**Information Request Response for Development Application for Reconfiguring a Lot – Impact Assessable – One (1) Lot into Three (3) Lots at 185 Postle Street, Mount Rascal, Qld 4350 (described as Lot 15 on SP295684) – RAL/2026/514.**

In accordance with the *Planning Act 2016* and on behalf of the applicant, Steinmuller Property Pty Ltd, we hereby respond to Council's Information Request, dated 24 February 2026, in its entirety and request Council to proceed with its assessment of the application. The responses provided herein, and attached supporting plans/documents provided, address all issues raised within Council's Information Request and provides all requested information as relevant/required.

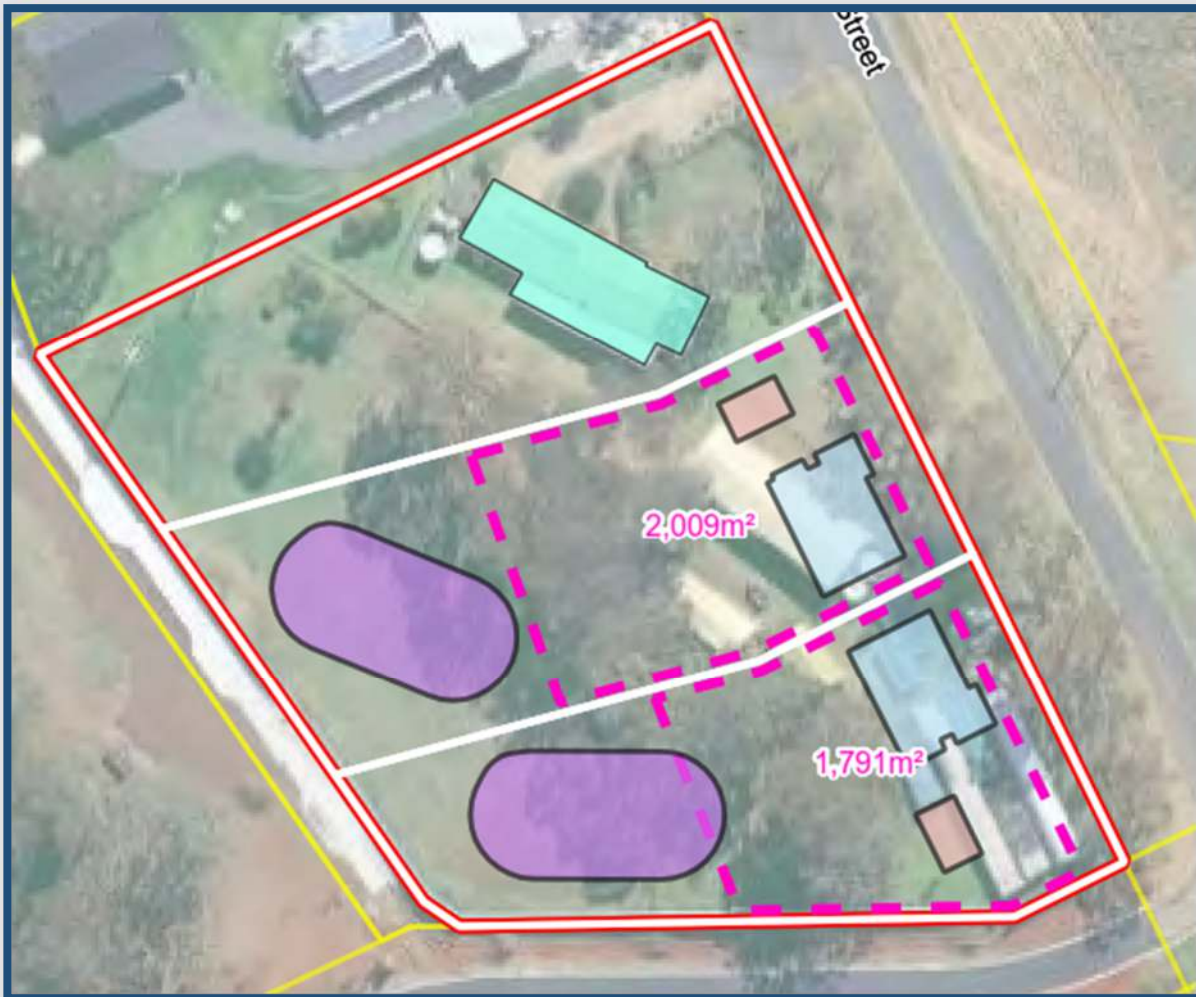
The submitted Potential Effluent Disposal Plan identifies potential dwelling house sites and the Bushfire Mitigation Plan identifies building envelopes, to demonstrate compliance with the relevant criteria. However, there is no consolidated building envelope plan which shows the developable portion of the site for a future dwelling house and ancillary structures.

Provide a Building Envelope Plan which demonstrates the useable portion of proposed lots 16 and 17 is sufficient in size to provide a dwelling house that maintains the residential amenity and landscape character of the surrounding area. The plan should include the following:

- Proposed boundary setbacks for the future dwellings, on proposed lots;
- Separation distances to existing and proposed adjoining development;
- Setbacks and separation distances as identified in the Bushfire Assessment report;
- Siting of any future dwelling in response to the steep topography;
- Separation distances to effluent application areas, for the future dwellings, on proposed lots; and
- Vegetation to be retained/removed within the proposed lots.

- The Bushfire Assessment Report submitted with the application allows for the use of approximately two thirds of the new lots (see Building Envelopes in Figure 12 of the BAR) for the Building;

The location of the concept future house sites, and alternate ones discussed above, will remain within the Building Envelopes nominated/identified within the Bushfire Assessment Report (BAR) provided with the application – which covers approximately two thirds of the lots – see below from Figure 12 of the BAR:
